Subject: Response to Requests for Additional Information in Support of the
Staff Review of the Application to Renew the Facility Operating Licenses
of McGuire Nuclear Station, Units 1 & 2 and Catawba Nuclear Station,
Units 1 & 2

Docket Nos. 50-369, 50-370, 50-413 and 50-414

Responses to NRC Requests for Additional Information
Concerning the Catawba Environmental Report
NRC Letter dated December 12, 2001

RAI 1 - Figure1

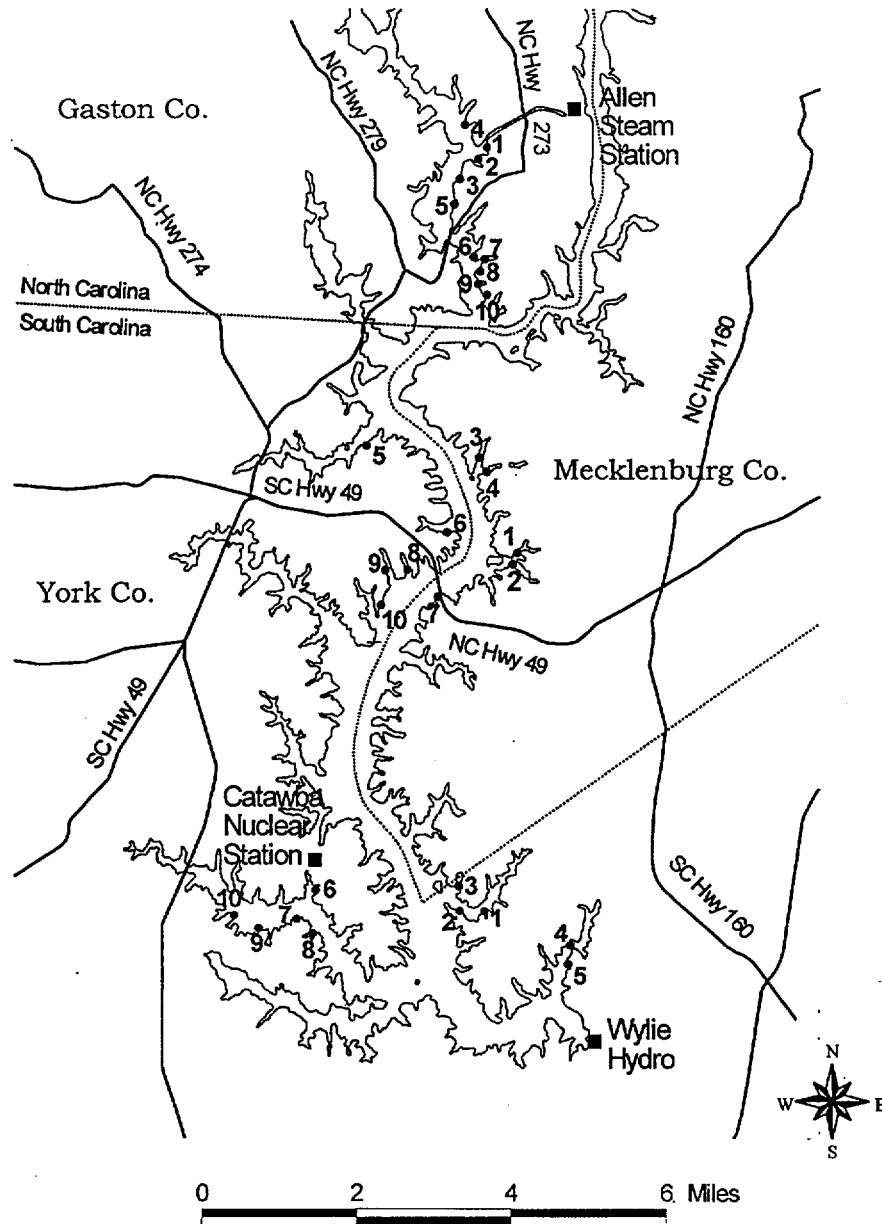
Provide a detailed written description of the aquatic ecology surveys conducted after the completion of the studies conducted for the 316(a) demonstration. The description should be written chronologically, with changes in the monitoring program described. At a minimum this should include:

- for fish species in Lake Wylie, a description of the methods used (such as gill netting, electro-fishing, purse seine), the timing of each survey, and locations surveyed; and
- similar information for surveys of benthic organisms, planktonic species, and other aquatic invertebrates is also requested.

Additionally, littoral (shoreline electrofishing) and limnetic (hydroacoustics and purse seine) fish community assessments were conducted on Lake Wylie during 1993 through 1997 and in 2000, as part of a watershed sampling program for the Catawba River reservoirs in North and South Carolina. A portion of the littoral fish community data collected during 1993 through 1997 are summarized in the October 2000 Duke Power Report "The Catawba". The limnetic fish community data collected during 1993 through 1997 are summarized in the Duke Power report *Catawba River Forage Fish Densities, Population Estimates, and Species Composition: 1993 –1997*. The littoral and limnetic fish community data collected during 2000 have not been summarized in a report.

Sampling locations for the watershed littoral fish community assessments conducted on Lake Wylie, NC/SC during 1993 through 1997 and in 2000.
